BEFORE THE BOARD OF COUNTY COMMISSIONERS  
FOR COLUMBIA COUNTY, OREGON

In the Matter of an Application by Dave )	
Molony for a Modification to a Previously )	FINAL ORDER NO. 41-2008
Approved Partition MP 07-37 and to )	
Modify Associated Columbia County )	FINDINGS AND CONCLUSIONS
Road Standards )

**SUBJECT:** PUBLIC HEARING  
MP 07-37- Modification of Prior Approval ( Planning Director's August 24, 2007 Final Order for MP 07-37 )  
Modification of Road Standards

**COLUMBIA COUNTY BOARD OF COMMISSIONERS**  
**AMENDED STAFF REPORT**

## Existing improvements of Cedar Springs Road

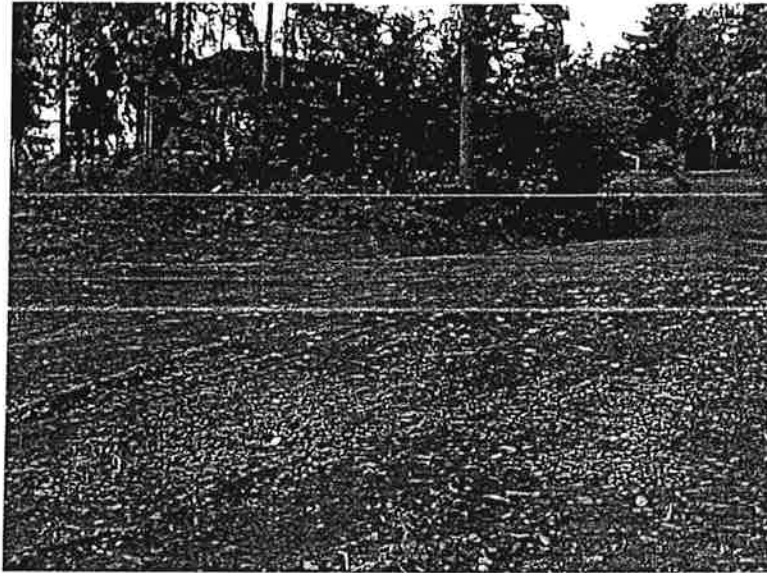
The applicant, Dave Molony, is requesting that the Board modify Condition 3 of the Planning Director's Final Order for MP 07-37 and a modification of road standards. The final decision for MP 07-37, Condition 3, requires him to widen and gravel the traveled surface of a local road, Cedar Springs Road, from its current

average width of 12-feet to a full 20-feet prior to final plat approval. Specifically, the applicant is requesting the Board to modify Condition 3 and Columbia County Road Standards to allow a 18', instead of the 20', traveled surface required by the County Road Standard for newly created parcels served by local roads, pursuant to specifications in Section VI. The area in question involves the widening and graveling of Cedar Springs Road from its intersection with Huber Road and continue South for approximately 540 feet to ensure both parcels have at least 50 feet of usable frontage on an existing county road, satisfying provisions of Section 1005.A of the Subdivision and Partitioning Ordinance.

Because Cedar Springs Road does not currently extend to both proposed 5-acre parcels, the applicant is also required to publically dedicate a 30'-wide by 125'-long strip of land that will extend Cedar Springs Road's public right-of-way to both parcels, and will require the applicant to construct a turnaround for emergency vehicles. The applicant is not requesting any modification of this additional public dedication, or the construction of this turnaround, for this newly dedicated public right-of-way.

- e. The area of each parcel.
3. The applicant shall survey Cedar Springs Road to determine the right-of-way boundaries, and the road surface shall be widened to County Road Standards to the maximum extent feasible as determined and approved by the Public Works Director, within the right-of-way, without damaging trees of six inches diameter or greater.
